**Comment Summary – November 21, 2024 (4<sup>th</sup> Submission)**  
**Zoning By-law Amendment Application – WDD Main St. Inc.**

**Re: Zoning By-Law Amendment 4th Submission  
11 Main Street (Morrison)  
Puslinch, ON**

**RE:** Hydrogeological Review Comments – 4<sup>th</sup> Submission  
WDD Main Street Inc. – 11 Main Street, Morriston (Puslinch), Ontario  
Proposed Residential Subdivision  
Zoning By-law Amendment / Draft Plan of Subdivision Application

File Number: 10779  
Drawn By: SM  
Planner: PT  
Scale: 1:1500  
CAD: 10040 Draft Plan D14 2024-09-03.dgn  
Drawing Number: **D14**

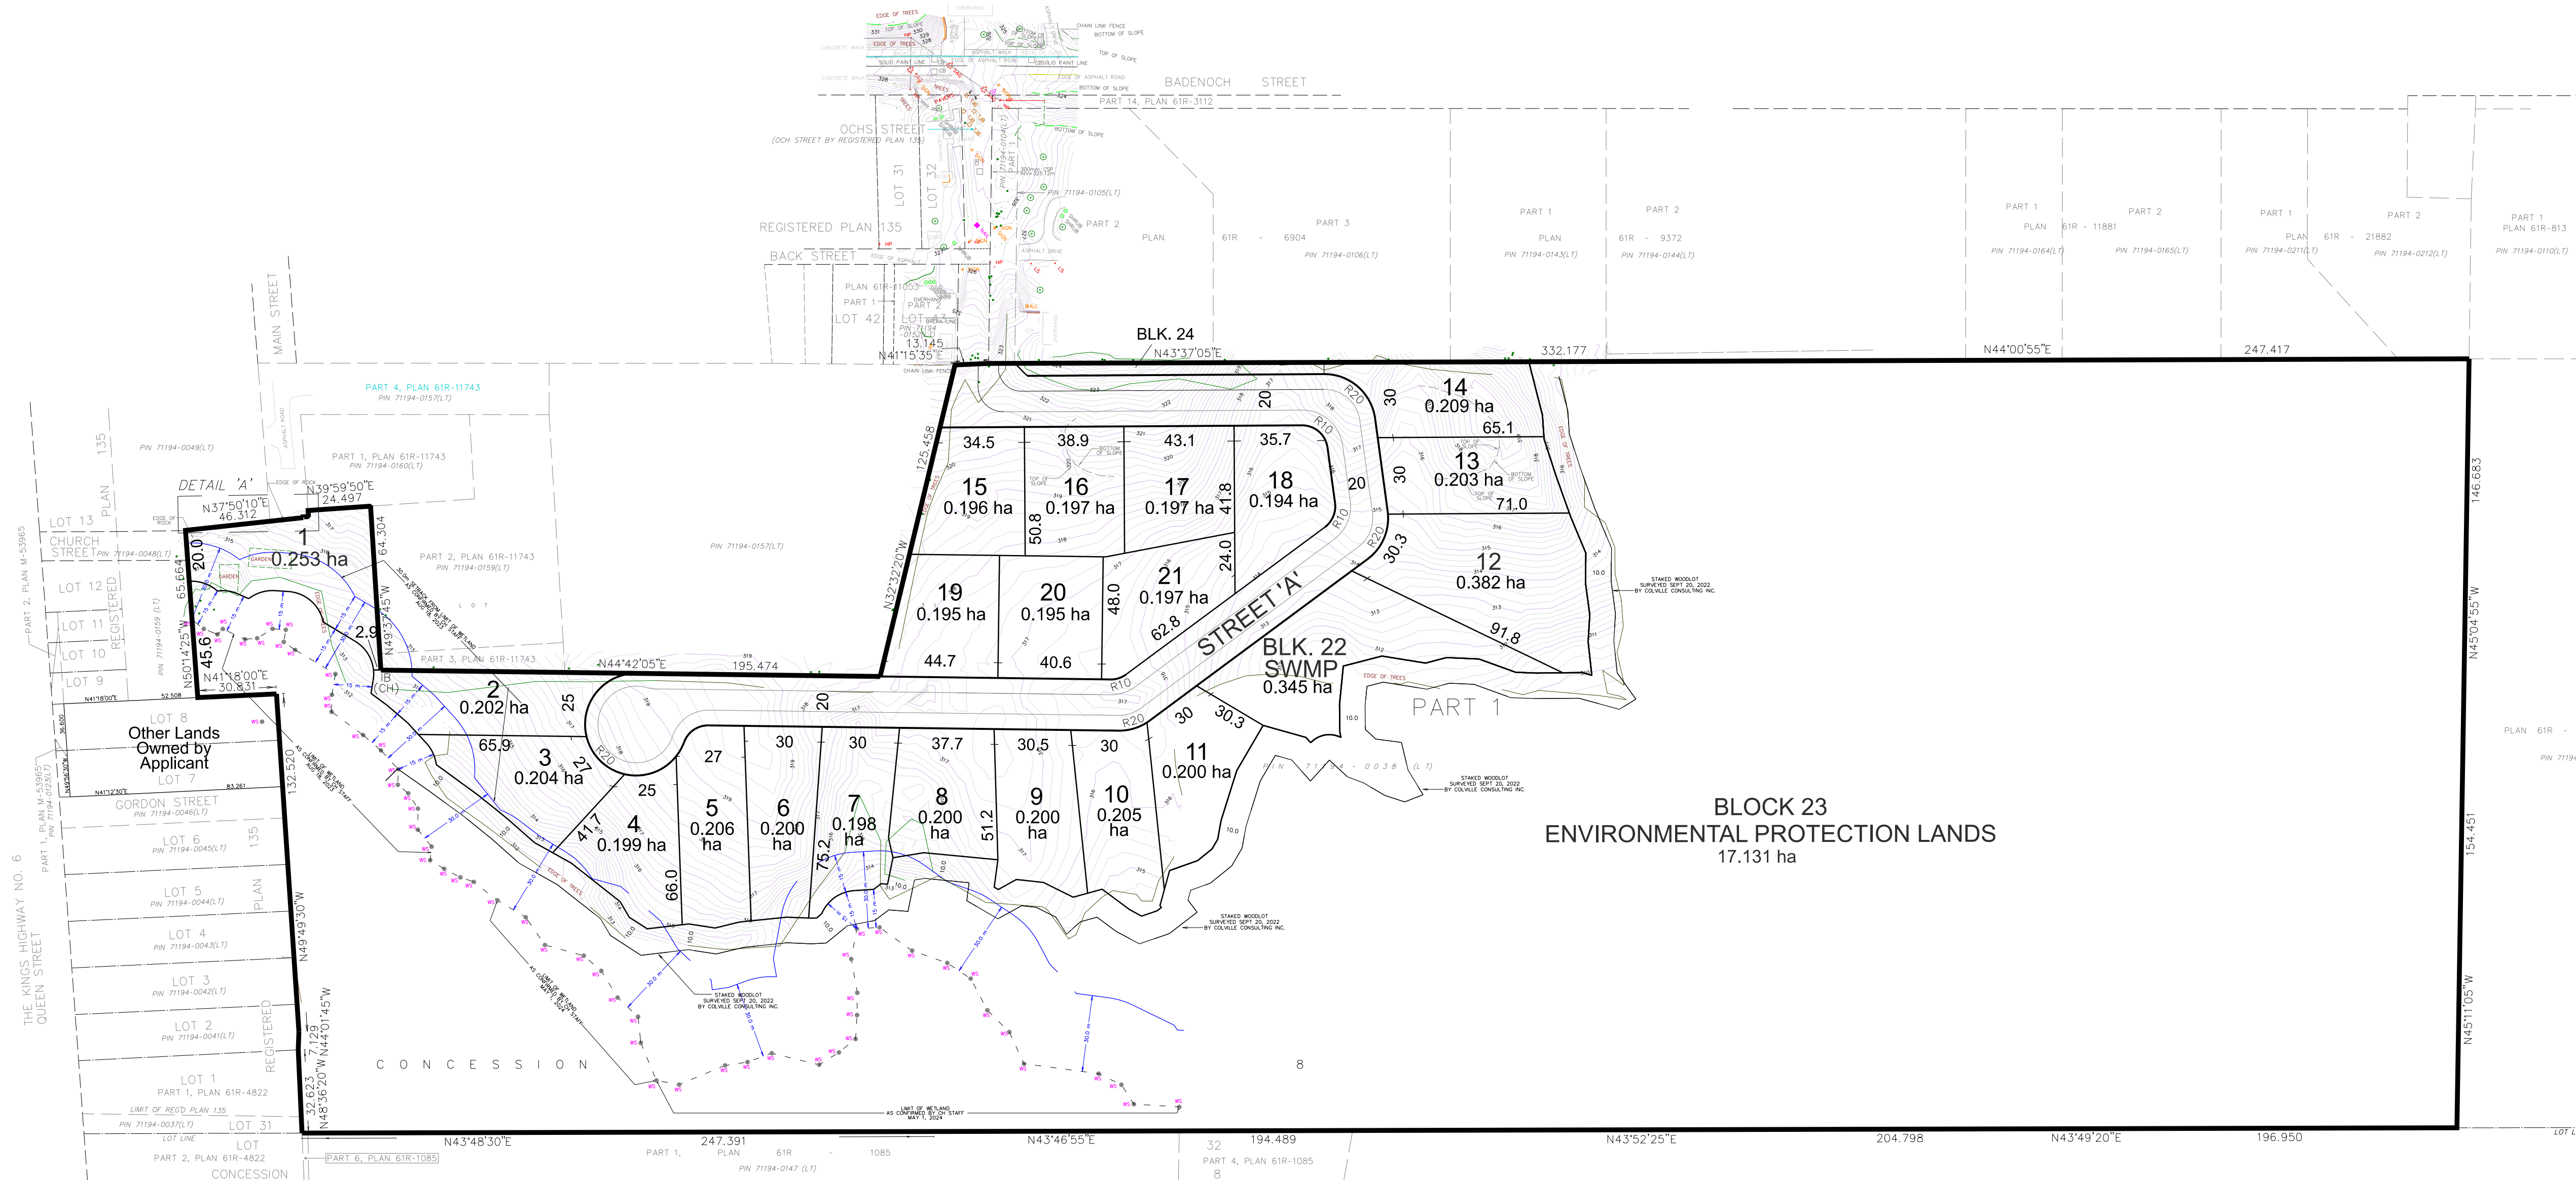
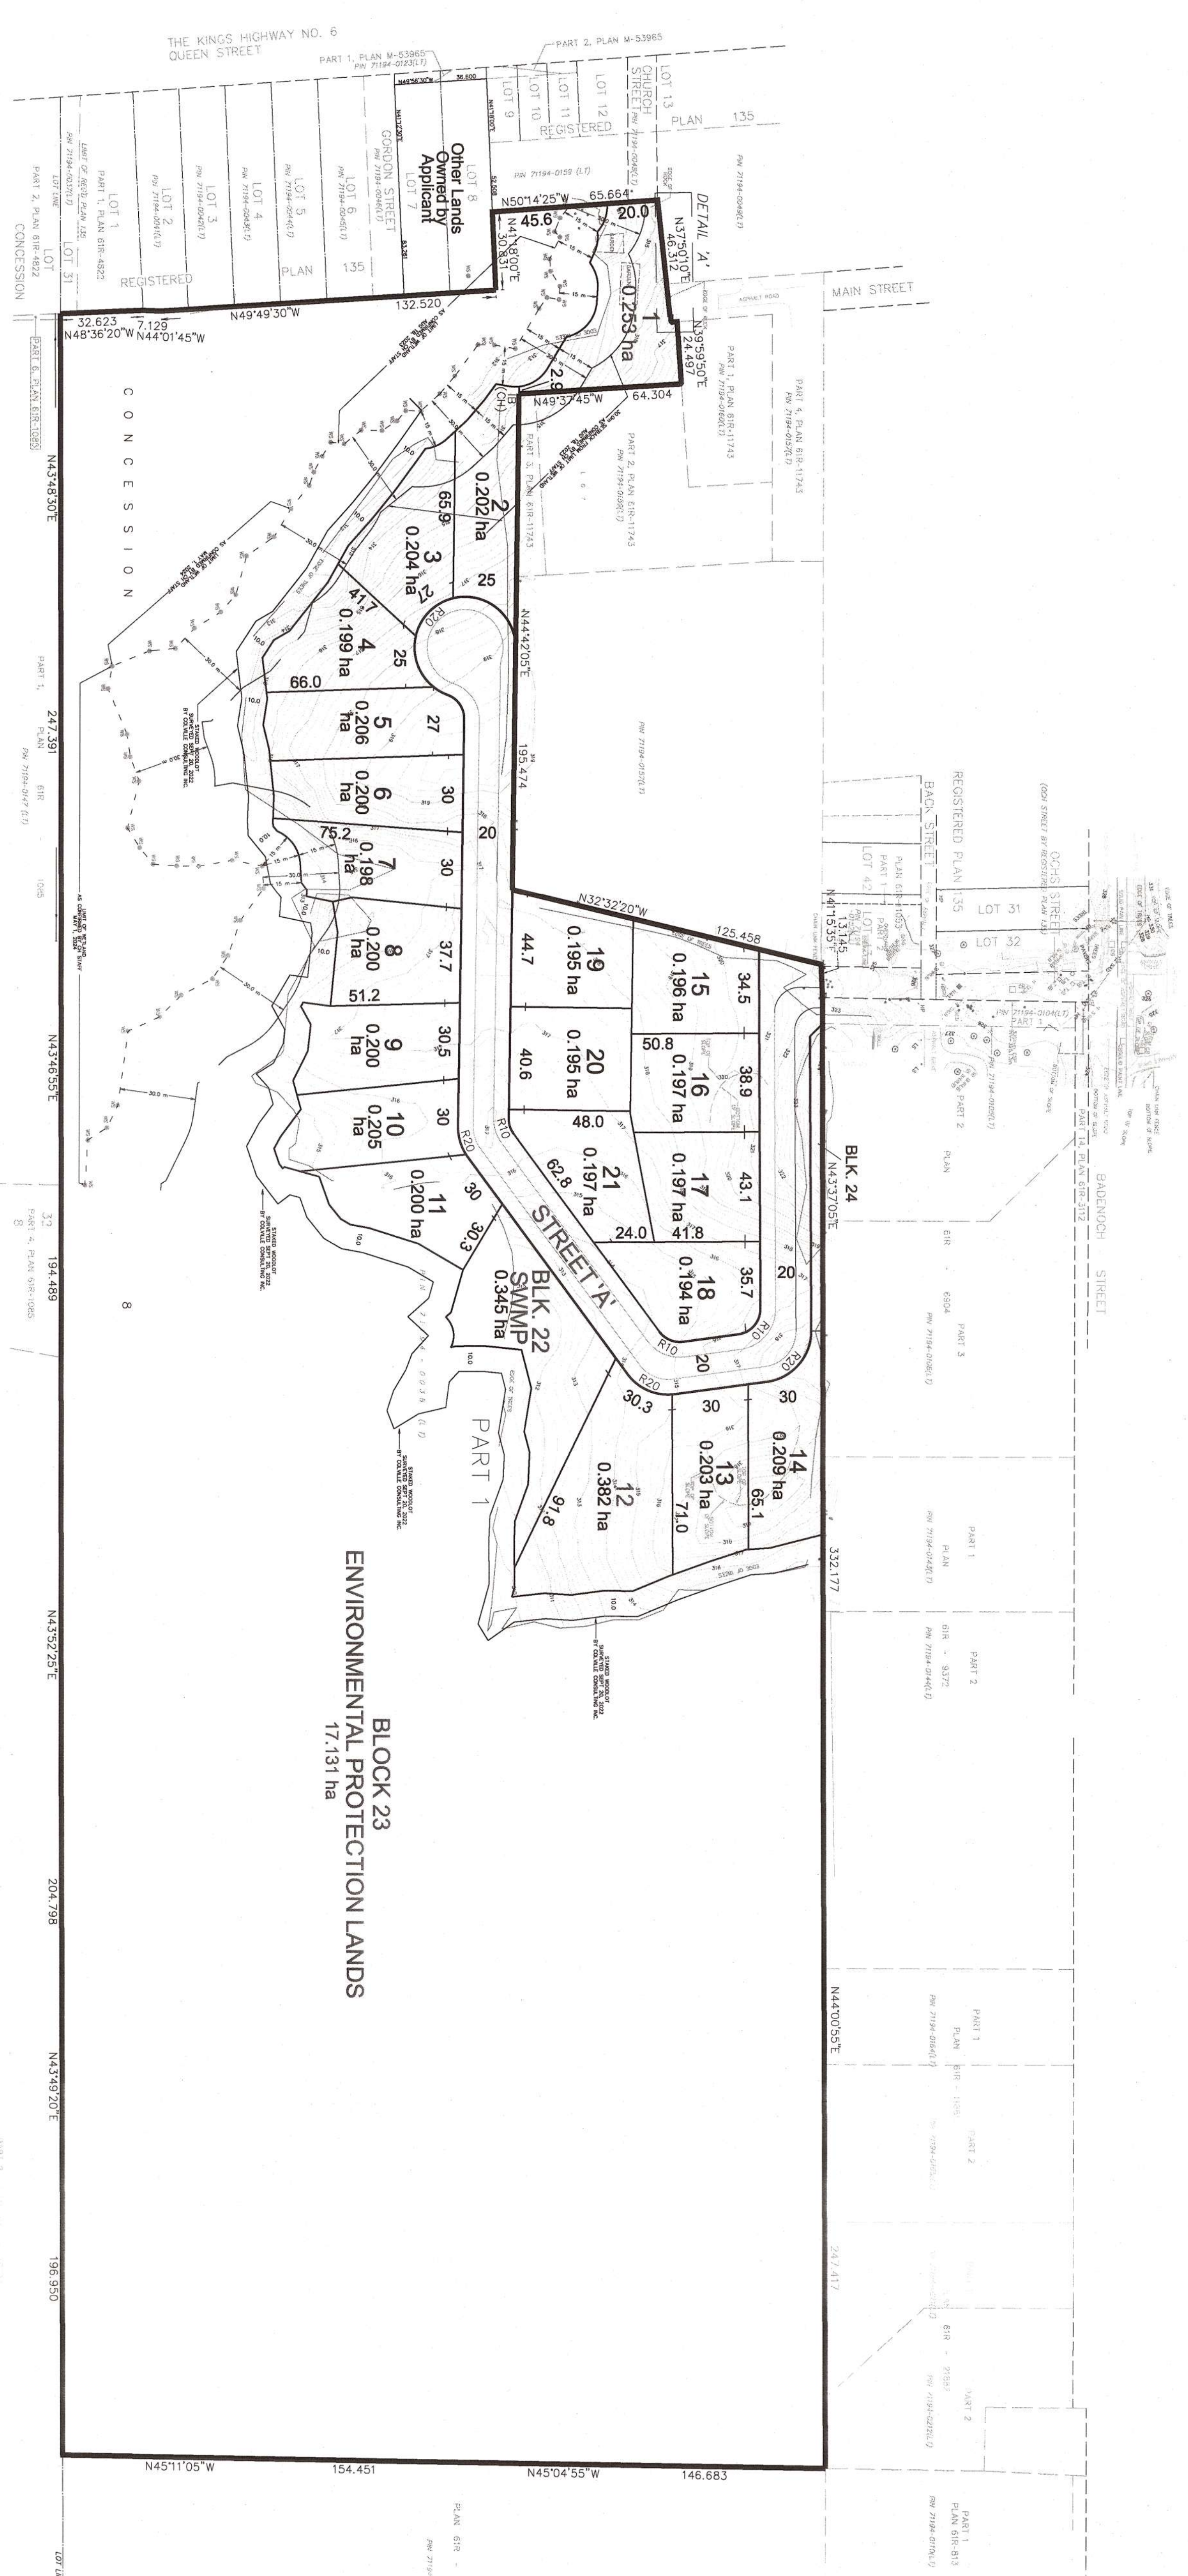
25.	Proposed Streets	Draft Plan	September 27, 2024	<u>GEI Comment (September 27, 2024)</u> The Draft Plan in previous submissions showed two proposed streets while the latest submission shows only one proposed street. Why has Street B been removed? How will emergency access be provided to the subdivision if Street A is blocked? The Township Public Works department should be consulted regarding the feasibility of a cul-de-sac of this length. The Catchment 201 and 202 paragraphs of Section 6.2 of the FSSWM report still refer to Street B and may need to be updated.  <u>Crozier Comment (November 2024)</u> The cul-de-sac and public road has been designed according to Town standards. Town fire reviewed the draft plan and did not advise of any concerns.  <u>GEI Comment (December 13, 2024)</u>

No.	Matter	Document	Date Identified	Comment
				We note that a second fire water storage tank has been added to the Preliminary Site Servicing Plans per Township Fire Service requirements. No further comment.
